Value Engineering

Mu2e Conventional Construction Value Engineering

Mu2e Value Engineering Report

VE Report for the conventional construction of the Mu2e facility.

Diesel to Gas Generator

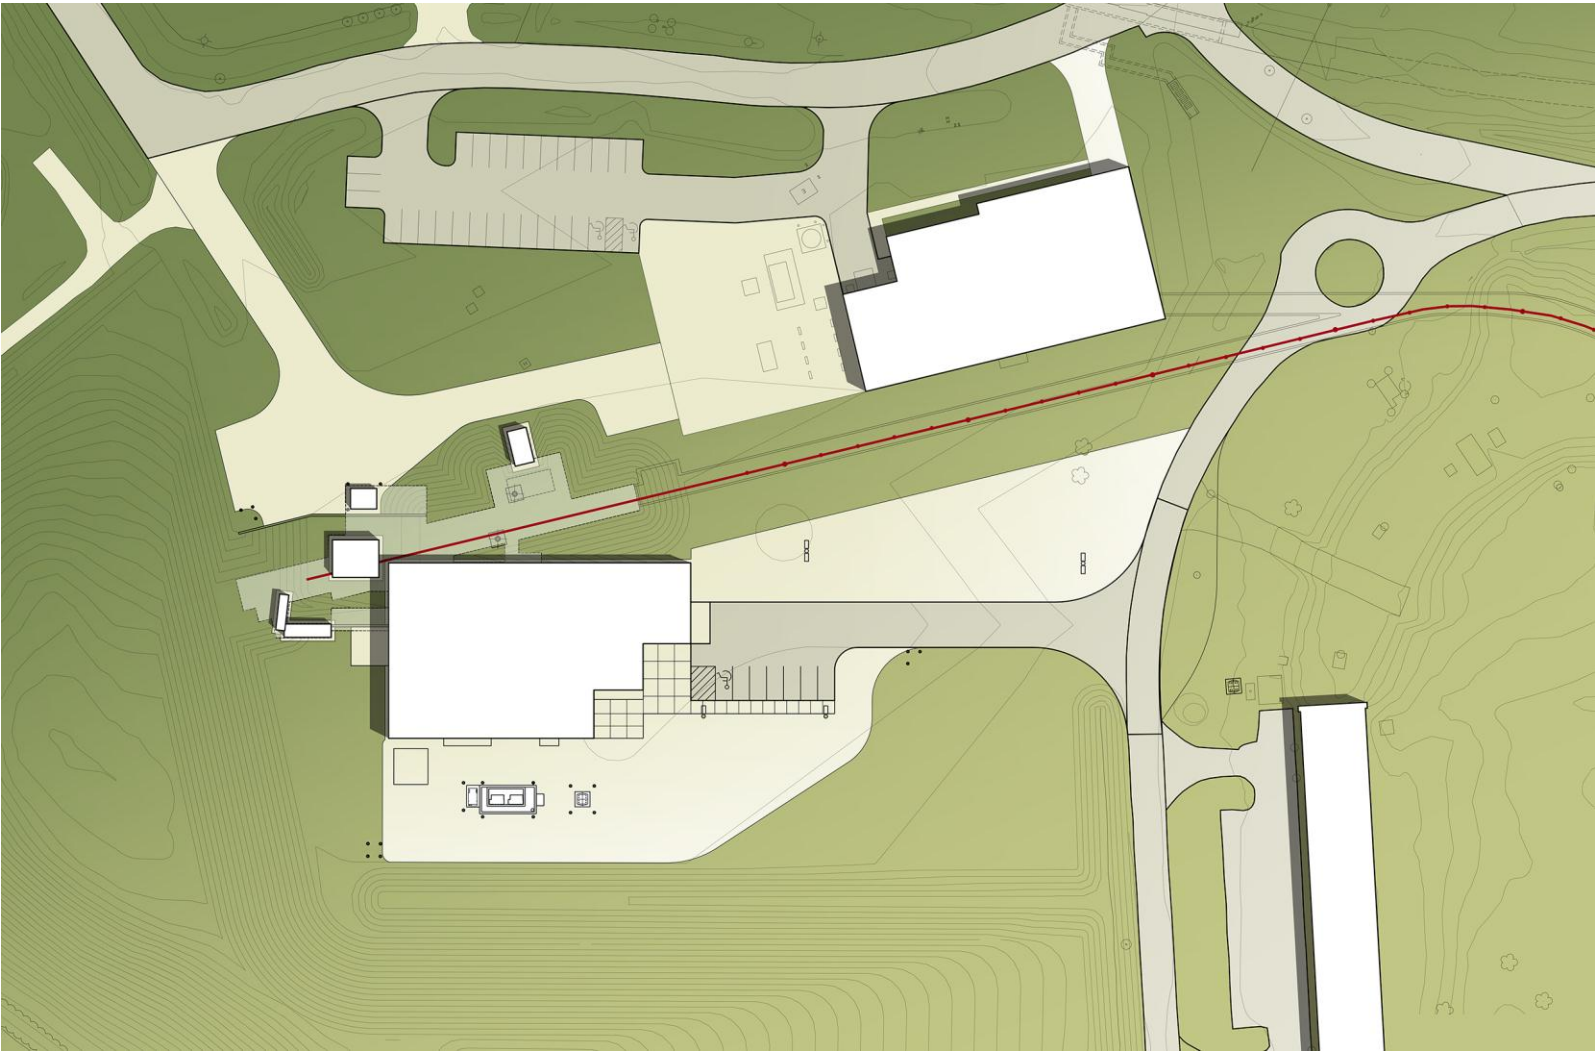
ORIGINAL DESIGN: The present design includes a diesel generator for standby power services in the building.

PROPOSED DESIGN: The proposed design would specify a natural gas generator in lieu of the diesel generator.

1. Natural gas line is routed adjacent to the generator
2. Natural gas does not require scheduled fuel deliveries
3. Natural gas does not pose a spill risk

1. Natural gas generators require larger engines for the same rating as diesel
2. Natural gas generators generally cost more than a diesel due to sizing
3. Relies on the natural gas distribution system
